Title/Titre SMP Trailer Assemblies	Solicitation No – N° de l'invitation W8486-217412/A Amendment 004
Date of Amendment – Date de Modification September 25, 2020 – 25 septembre, 2020	
Address Enquiries to – Adresser toutes questions à Contracting Authority: Name: Tanya McKenzie Directorate: DLP 5-2-1 National Defence Headquarters 101 Colonel By Dr. Ottawa, Ontario K1A 0K2	
Telephone No. – N° de téléphone 819-936-6471	Email – Courriel Tanya.mckenzie@forces.gc.ca
Destination Specified Herein Précisé dans les présentes

Amendment 004

This amendment is raised to publish questions and answers.

Regarding the drawings provided for Item 5 + 6 (5120-20-002-4369):

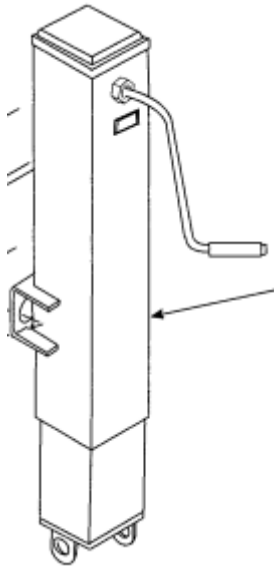
0377386 – Jack Stand (modified) – states “remove and discard existing Pin Assy” – There is no cross-reference to a new pin assy drawing # in this drawing, however drawing 0377651 was provided. Is this drawing the replacement Pin Assy we are to discard? If so, what finish is required for this Pin Assy?

0377650 – Bracket for Jack Stand (there are two drawings referencing the “bracket”. Which one is correct?

On Drawing 0377386, the Jack Part#0091340 which is the Jack to be modified, comes with a pin and a leg that need to be discarded.

To make this one:

The drawings 0377650 and 0377651 are not part of this modified Jack and should be removed.

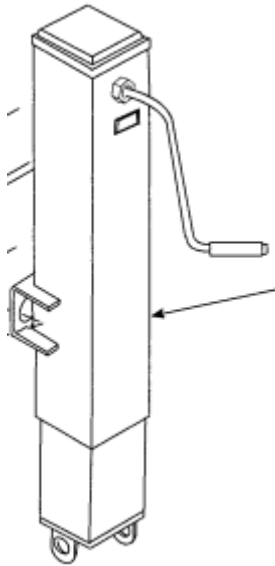
0377386 - Cric de remorque (modifié) - indique «supprimer et éliminer l'assemblage de goupille existant» - Il n'y a pas de référence croisée à un nouveau dessin d'assemblage de goupille dans ce dessin, cependant le dessin 0377651 a été fourni. Est-ce que ce dessin représente l'assemblage de goupille de remplacement que nous devons jeter? Si oui, quelle finition est requise pour cet assemblage de goupille?
0377650 - Support pour le cric (il y a deux dessins faisant référence au «support». Lequel est correct?

Sur le dessin 0377386, le Cric de remorque No #0091340 qui est le cric à modifier, est livré avec une goupille et une jambe qui doivent être jetées.

Pour faire celui-ci :

Les dessins 0377650 et 0377651 ne font pas partie de ce cric de remorque modifié et doivent être supprimés.
